## MEMORANDUM

<b>Date:</b>	November 3, 2014	<b>TG:</b>	14163.00
<b>To:</b>	Tom Hansen, PE – City of Woodinville		
<b>From:</b>	Mike Swenson, PE, PTOE Jesse Birchman, PE, PTOE		
<b>cc:</b>	Maira Haughian – The Blueline Group		
<b>Subject:</b>	Woodinville Church Subdivision – Response to TIA Comments

# Sight Distance Analysis - NE 205th St

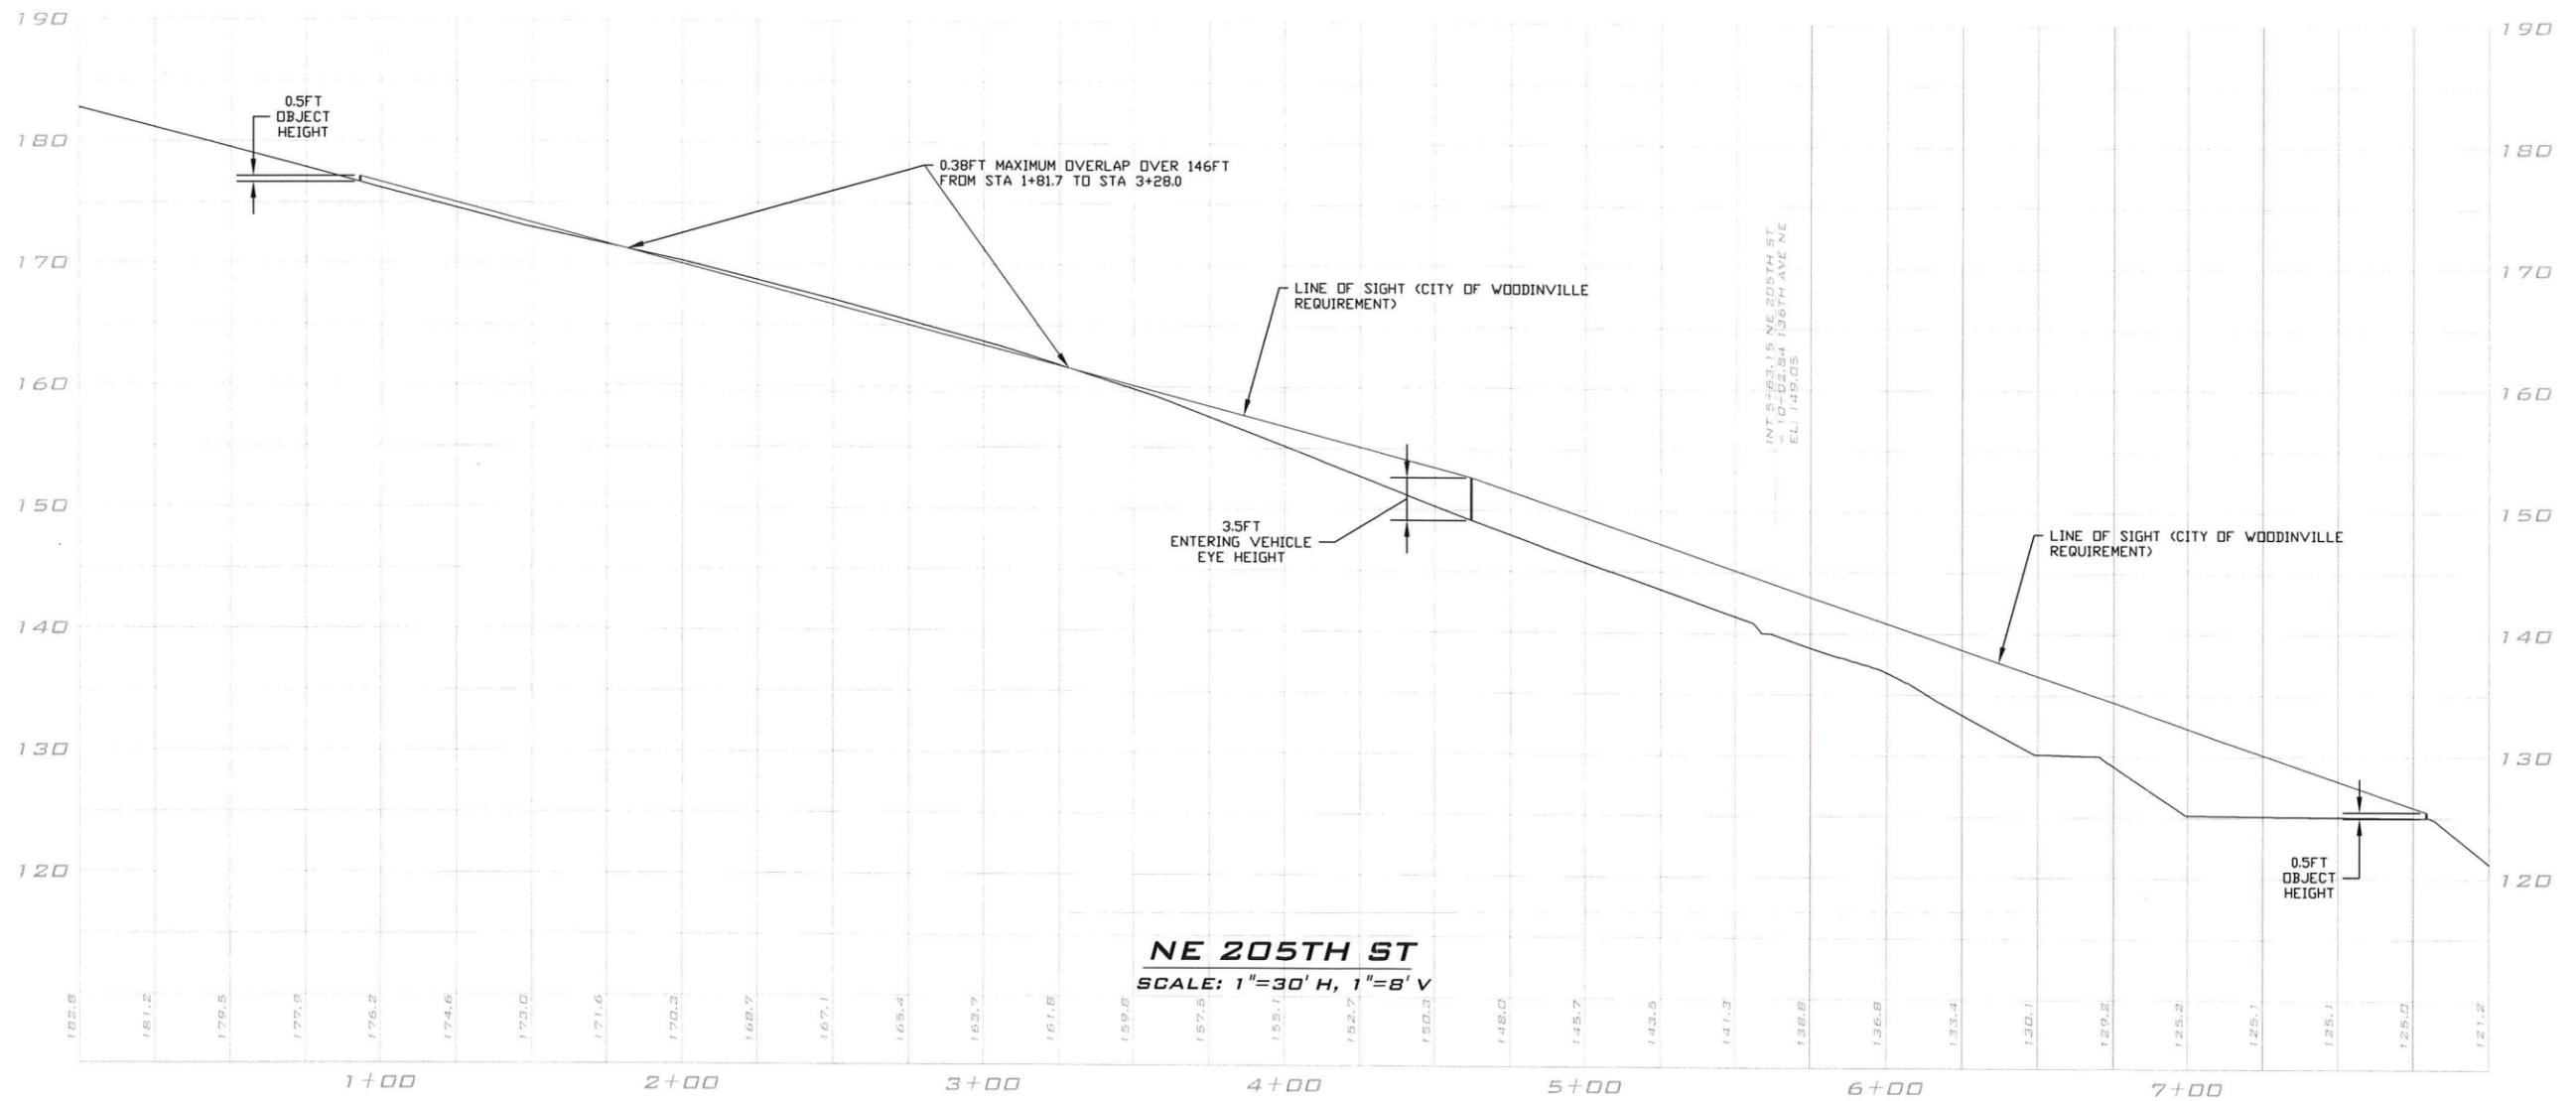
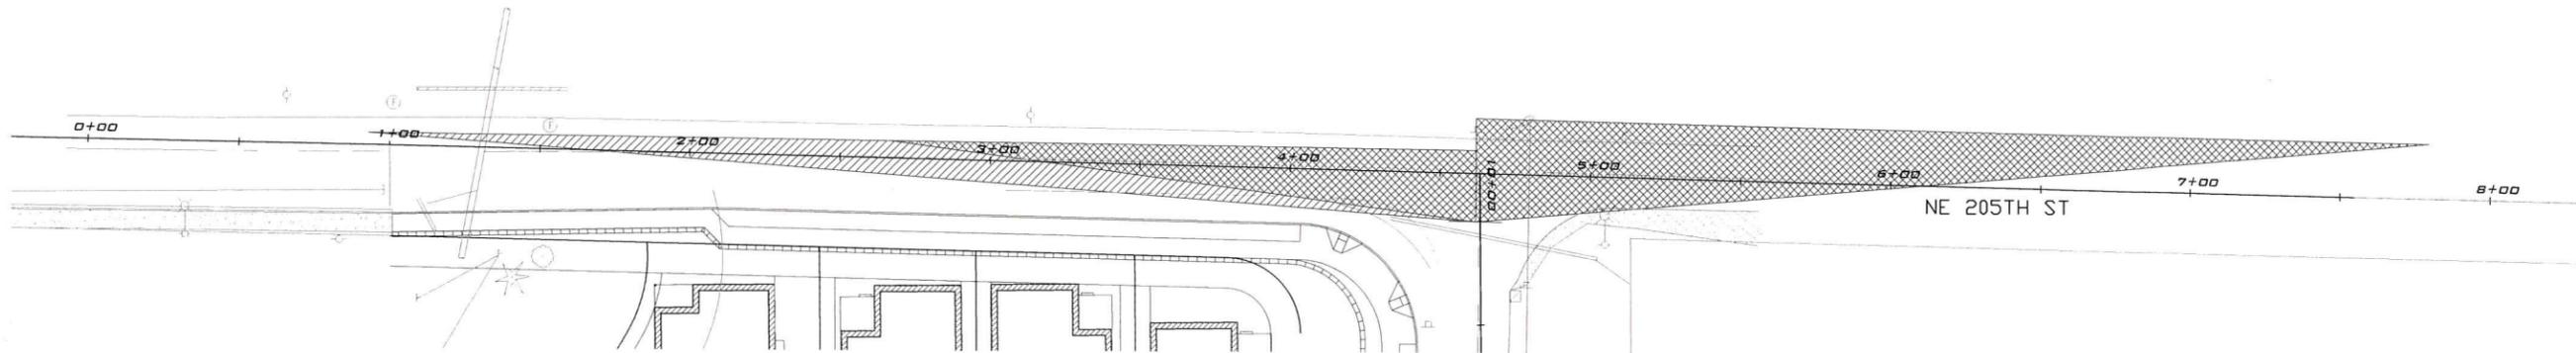
**Public Works** - The Transportation Impact Analysis included an intersection sight distance and stopping sight distance analysis that did not take into account the vertical curve. Please submit an updated analysis after review.<sup>1</sup>

**Construction** - The Transportation Impact Analysis does not include a vertical sight distance analysis, please submit.<sup>2</sup>

An evaluation of vertical sight-distance at the NE 205th Street / 136th Avenue NE intersection and site access driveway onto 136th Avenue NE is provided as Attachment A and B, and demonstrates that City of Woodinville sight-distance requirements specified in are not met. On NE 205th Street west of 136th Avenue NE, sight-distance is obstructed by approximately 0.38 feet (approximately 4.5 inches) of the roadway surface profile. On 136th Avenue NE between NE 205th Street and site access driveway the roadway surface profile would obstruct sight-distance by 0.05 feet (approximately 5/8ths of an inch) due to the vertical curvature of the roadway surface.

Based on this, sight distance at the site access driveway on 136th Avenue NE and NE 205th Street were compared to national sight-distance standards for stopping and intersection/entering sight-distance provided in the American Association of State Highway Transportation Officials (AASHTO) *A Policy on Geometric Design of Highways and Streets* (2011). Attachments C through Attachment F illustrate that AASHTO stopping and entering sight distances requirements would be met along both NE 205th Street and 136th Avenue NE with construction of the proposed frontage improvements.

Stopping Sight Distance Analysis - NE 205th St

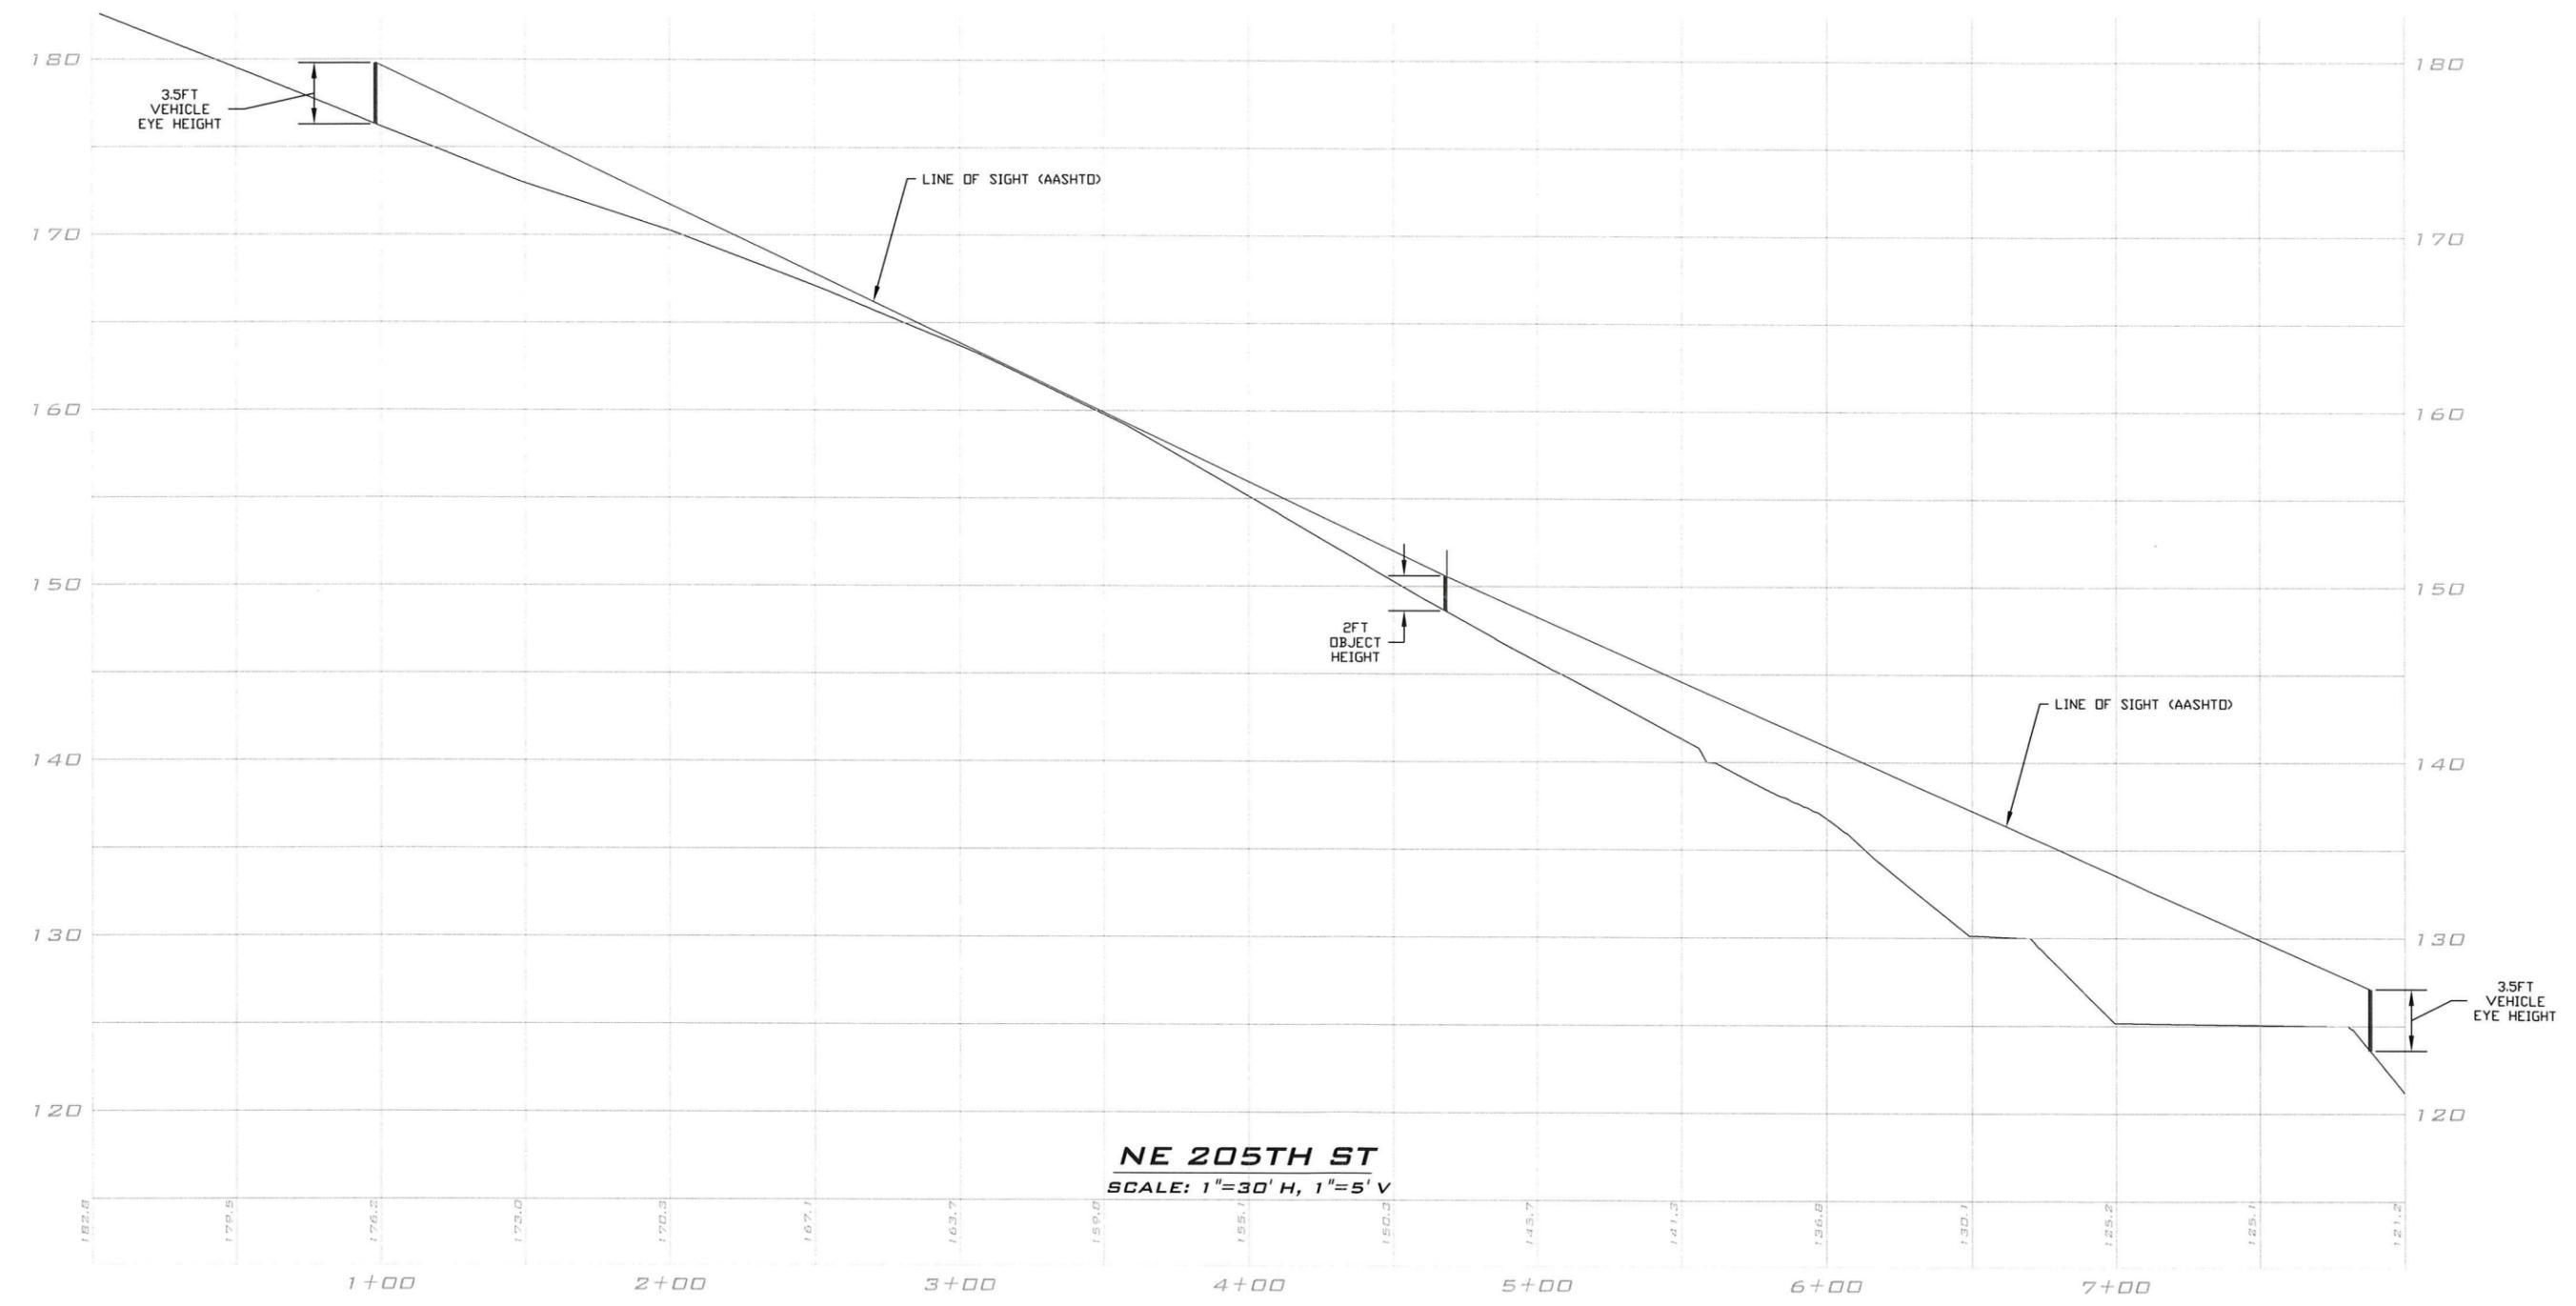
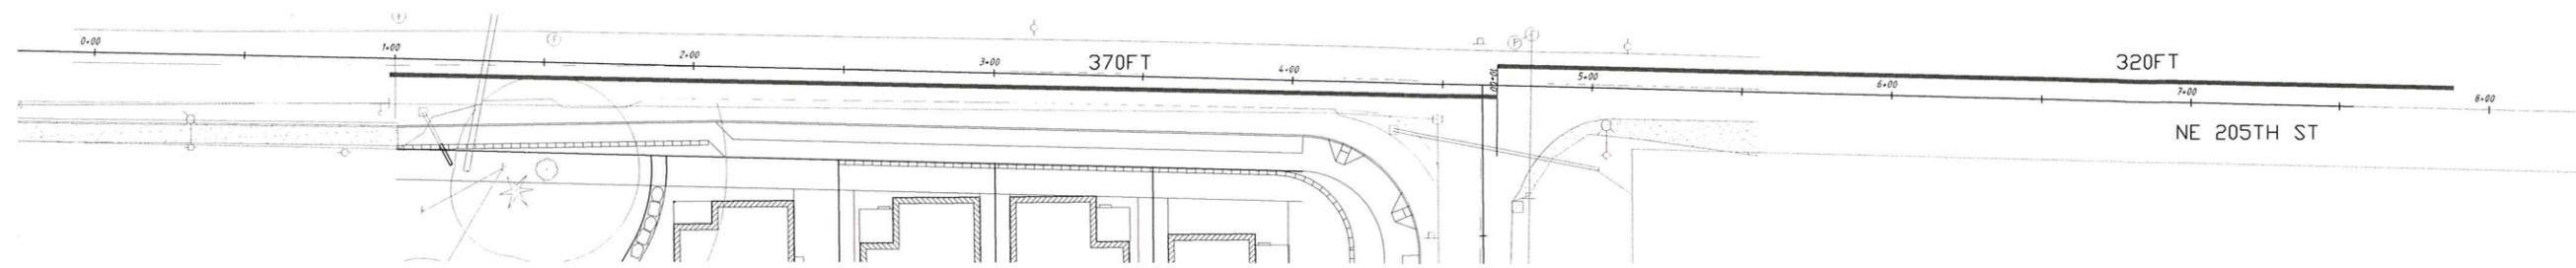
- Concern of low-visibility at the NE 205th Street / 136th Avenue NE intersection
- A request that sidewalk be provided at the NE 205th Street / 136th Avenue NE intersection
- Concern of vehicle speeds along NE 205th Street-244th Street SE

An updated evaluation of sight-distance consistent with AASHTO requirements was completed at the NE 205th Street / 136th Avenue NE intersection and is summarized in Attachments C through Attachment F. This evaluation was based on the proposed site plan provided as Figure 2 within the TIA and includes frontage related improvements. These frontage improvements include curb, gutter, and sidewalk along both NE 205th Street and 136th Avenue NE. As shown in these attachments, sight-lines with these frontage improvements would meet AASHTO design requirements while minimally exceeding City of Woodinville requirements. The provided sidewalks along the proposed project's frontage would connect to the sidewalks currently provided along the frontage of the adjacent parcels.
